**ISSUE:** Permit to Demolish/Capsulate (partial) and Certificate of Appropriateness for alterations

**LOCATION:** Old and Historic Alexandria District  
724 North Washington Street

**BAR #2021-00416 & BAR #2021-00417**  
**724 North Washington Street**

DEMOLITION  
724 NORTH WASHINGTON STREET  
ALEXANDRIA VA 22314  
SOUTH-WEST

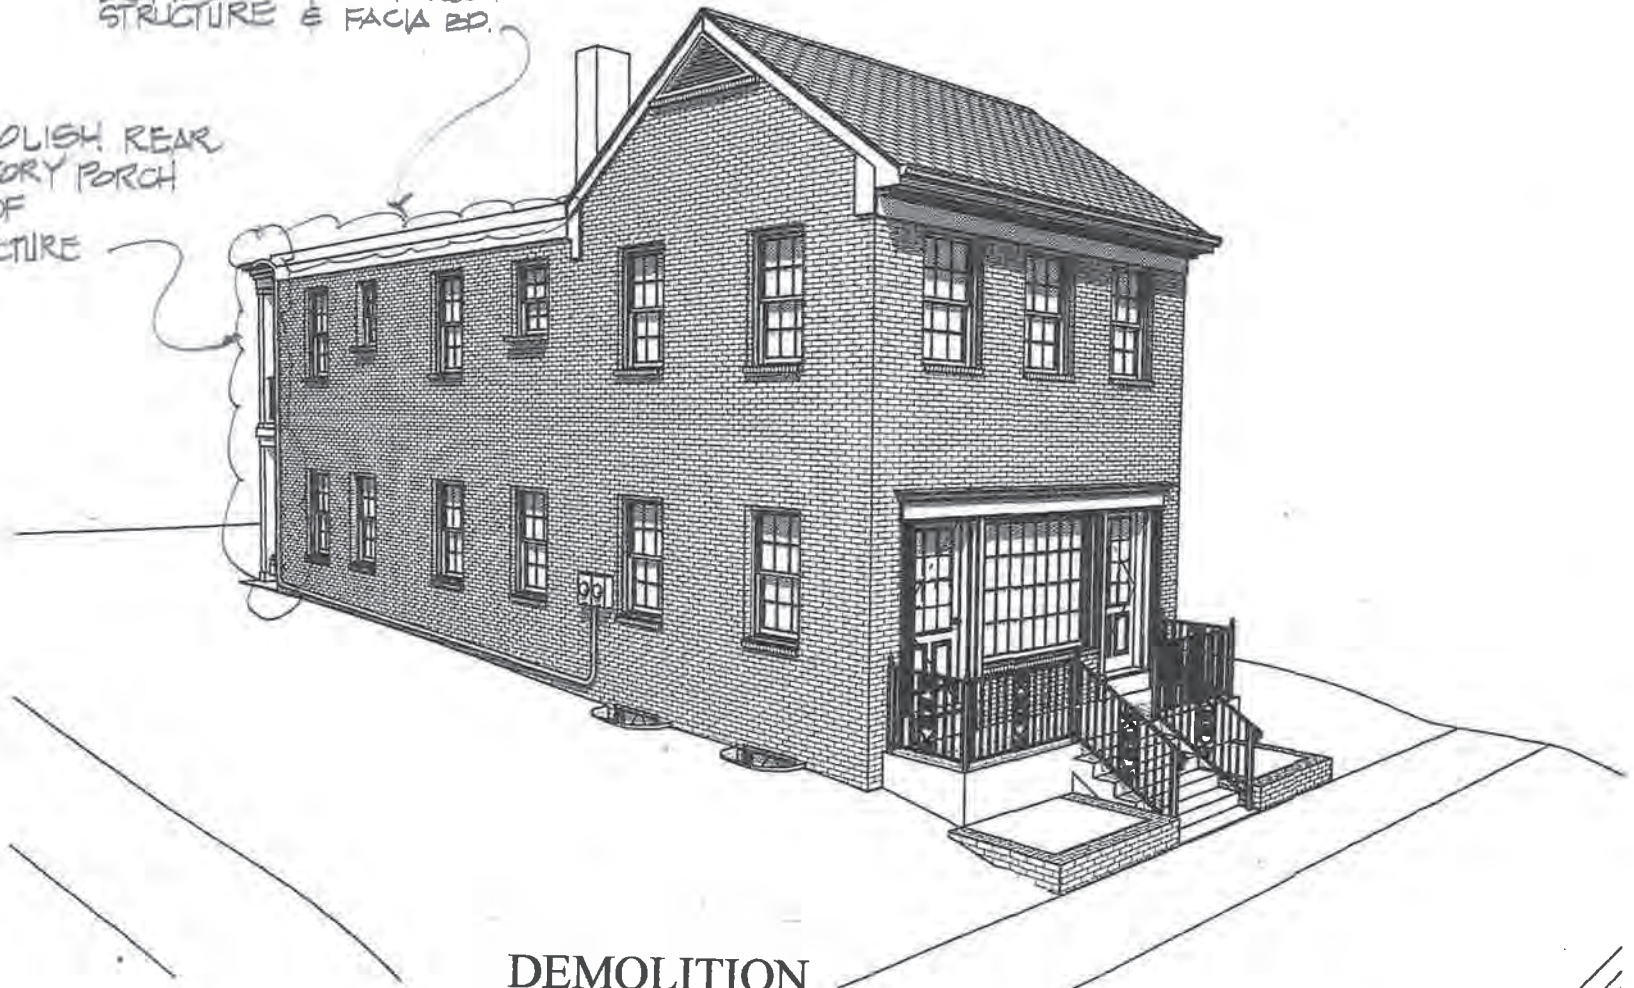
According to documentary evidence and site observation, the two-story porch on the west side of the building was constructed in 2011 and replaced a similar deck in the same location. The existing deck includes simple wood columns with a simple cornice and vertical picket railings. These elements are not particularly unique in design or construction and given their age could easily be reproduced.

The construction of the proposed addition will require the demolition of the west wall of the existing structure. It appears from documentary evidence that there was always some type of deck on this elevation that at least partially obscured the building façade. As such, the design for the façade is utilitarian in nature and clearly intended to be a secondary design feature. The two ground floor doors are raised panel and their spacing appears to be driven by interior conditions rather than an exterior composition. The door and window on the second floor align with features below but these are also simple in design and construction. The design for the west façade of the building is clearly not critical to the design of the overall structure and since none of the building components are particularly unique, staff supports the proposed demolition.

The applicant is proposing to demolish the existing low slope roof on the ell of the structure in order to rebuild it at a different slope that will align with the slope of the addition. Staff is often concerned about the removal of an existing roof form because that form can be a character defining feature in its own right. In this case, the direction and configuration of the sloped roof will remain the same, the slope will just become steeper. The building also features a tall parapet at the north, high side, of the existing roof which conceals the roof slope from view from this side. The applicant is proposing to keep this parapet and include one of a matching height on the addition that will further obscure any view of the roof. As the roofing material itself is not unique, the roof configuration is being minimally changed, and the roof form does not contribute to the overall design for the building, staff supports the proposed demolition.

PROPOSED WEST ELEVATION  
 $\frac{1}{8}" = 1'-0"$

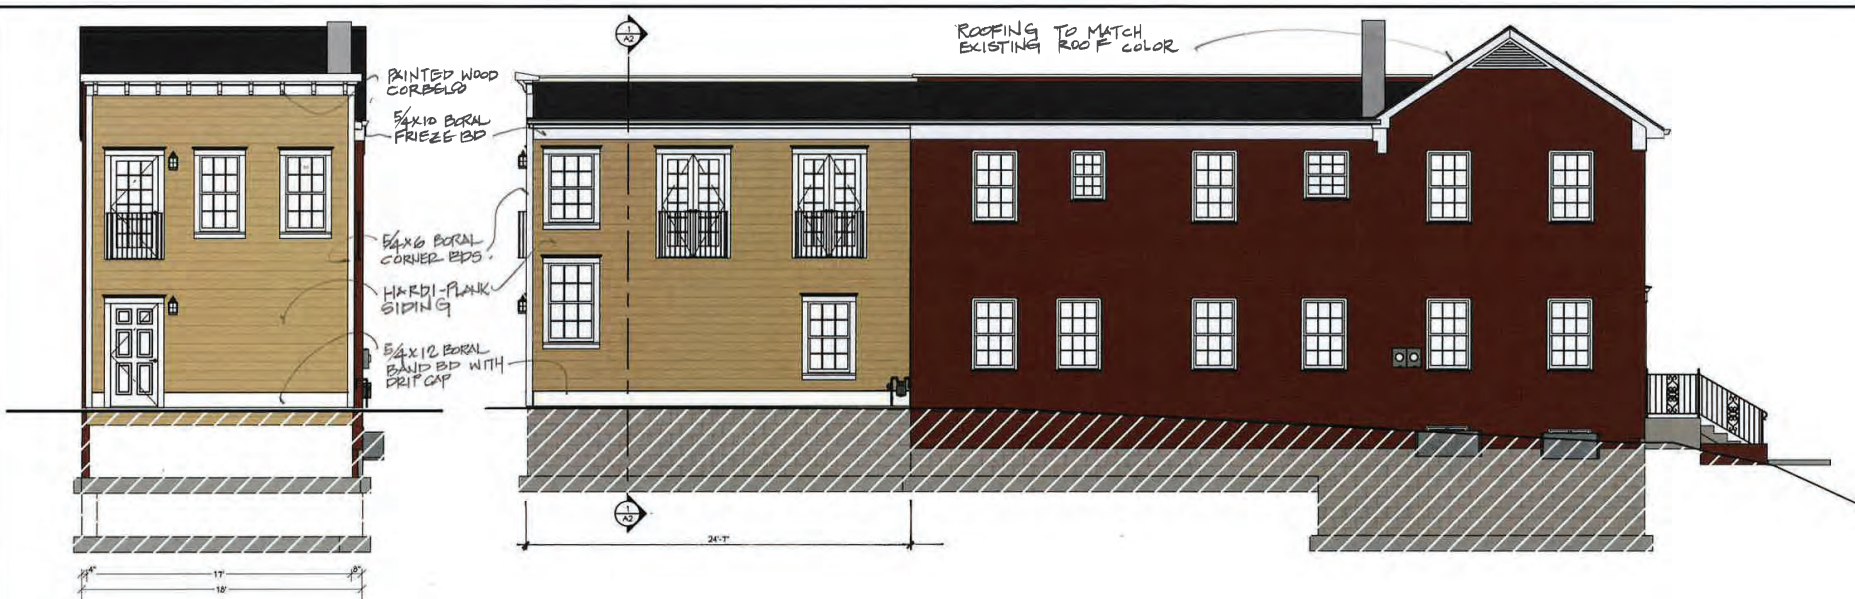
Staff finds that the continuation of the existing parapet on the north and west elevations is an effective way to conceal the roof slope and carry the proportions of the existing building into the addition. The proportions of the detailing for the proposed cornice on the west elevation is somewhat awkward and out of scale with the remainder of the elevation. Staff recommends that the applicant work with staff on the design and detailing of this feature to make it more compatible with the existing building.

The presence of an interior stair in the southwest corner of the addition is causing the first and second floor windows on the west side of the south elevation to not be aligned with other adjacent windows. At the second floor, the windowsill does not align with the adjacent windows on the west elevation. At the first floor, the window is larger and not aligned with the other double hung window on the east side of the south elevation. These misalignments make for an unbalanced composition that is not compatible with the more rigid composition of elevations on historic buildings. Staff recommends that the applicant work with staff to resolve these alignments.

1. Work with staff on the final detailing of the trim at the cornice on the west elevation of the addition.
2. Align the two ground floor windows on the south elevation of the addition.
3. Align the sill of the window on the second floor of the south elevation with the sill of the windows on the west elevation.
4. The applicant submit updated window specifications with the building permit to confirm that the proposed windows meet the *Alexandria New and Replacement Window Performance Specifications in the Historic District*.
5. The fiber cement siding is to be painted, with a smooth finish.
